## AGENDA

- a. Discussion and action on a Site Design Review Permit submitted by Matt Schuenke, Village Administrator, for Phase 2 improvements to the Community Park located at 3234 County Highway AB.
- b. Discussion and action to make a recommendation to the Village Board regarding Resolution 2025-17, a resolution authorizing the Village Administrator to execute a pre-development agreement with Elvehjem Acres LLC and Bliffert Southwest Holdings LLC.
- c. Discussion regarding land division and zoning public notices.

**VILLAGE OF  
McFarland  
SUMMARY SHEET**

We have received the proposed plans for Phase 2 improvements to Community Park, a Village-owned 26-acre site immediately east of CTH B and south of Siggelkow Road. Our comments are shown below, organized by the appropriate document and/or drawing sheet number.

Sheet Number  
**C300**

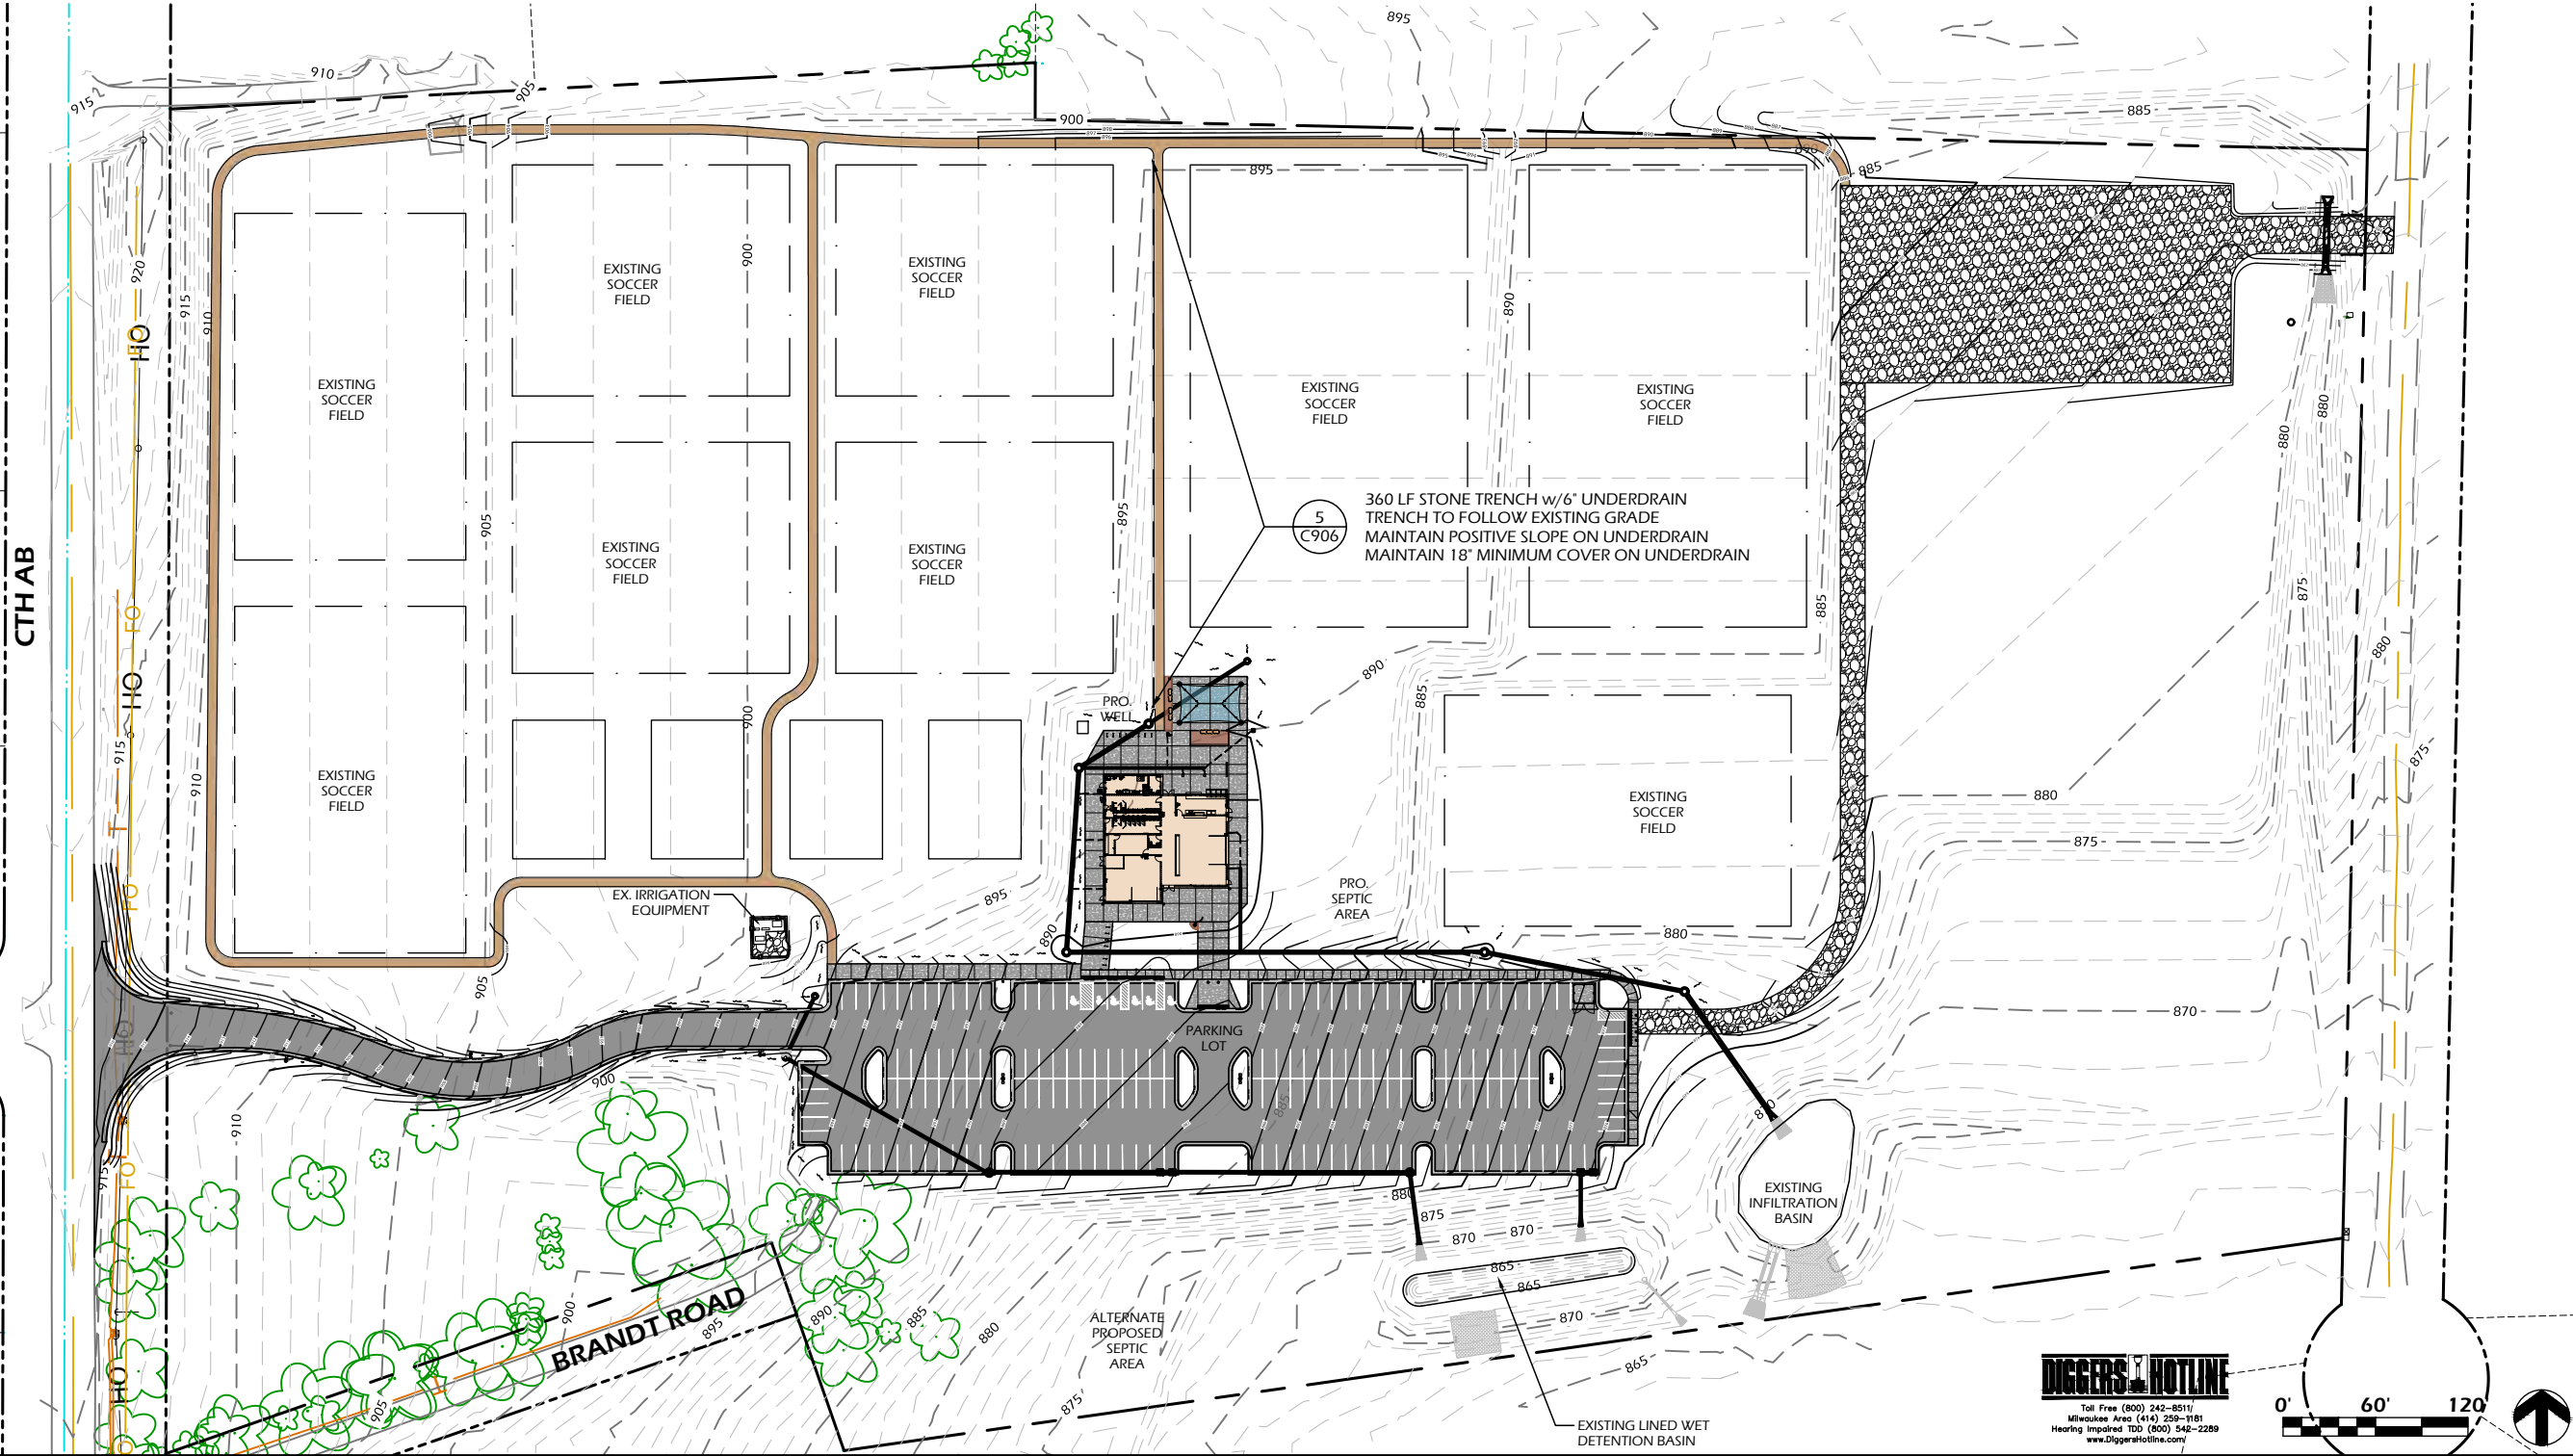
Sheet C300

*Curb cuts have been added approximately every 50 feet along the driveway.*

Sheet Title: **GRADING & UTILITY PLAN - EAST GRAVEL LOT**

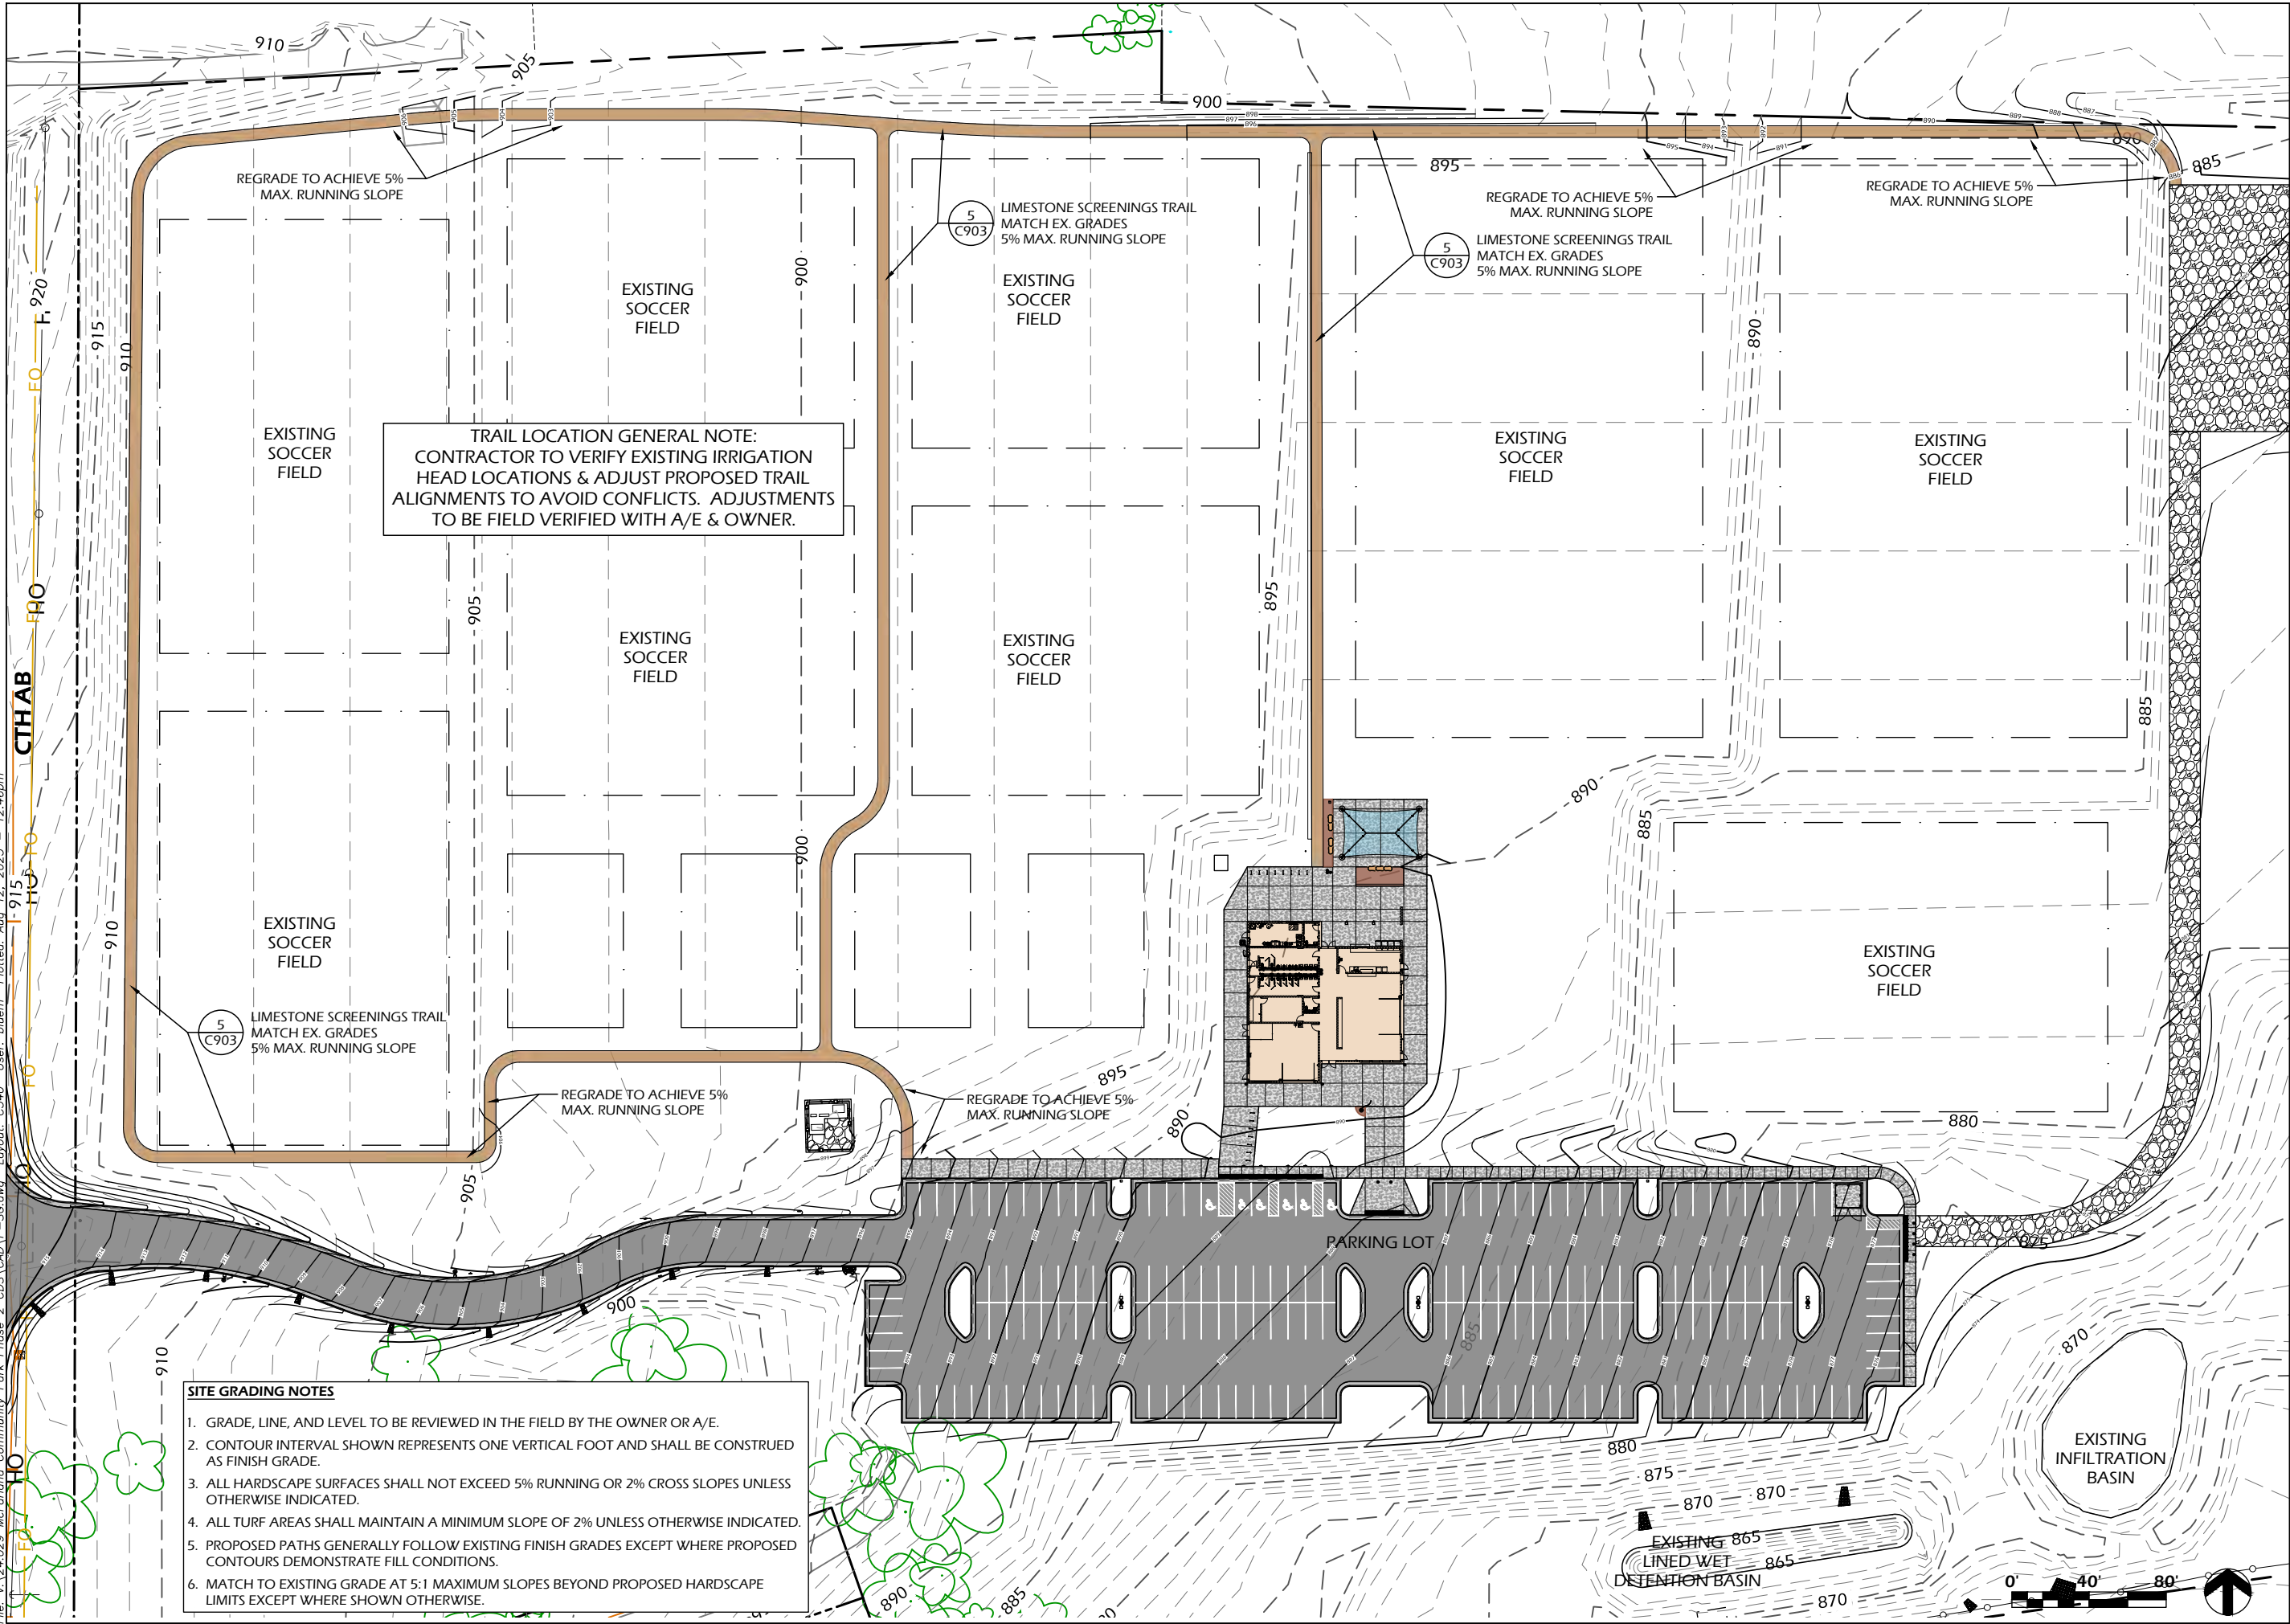
Sheet C330
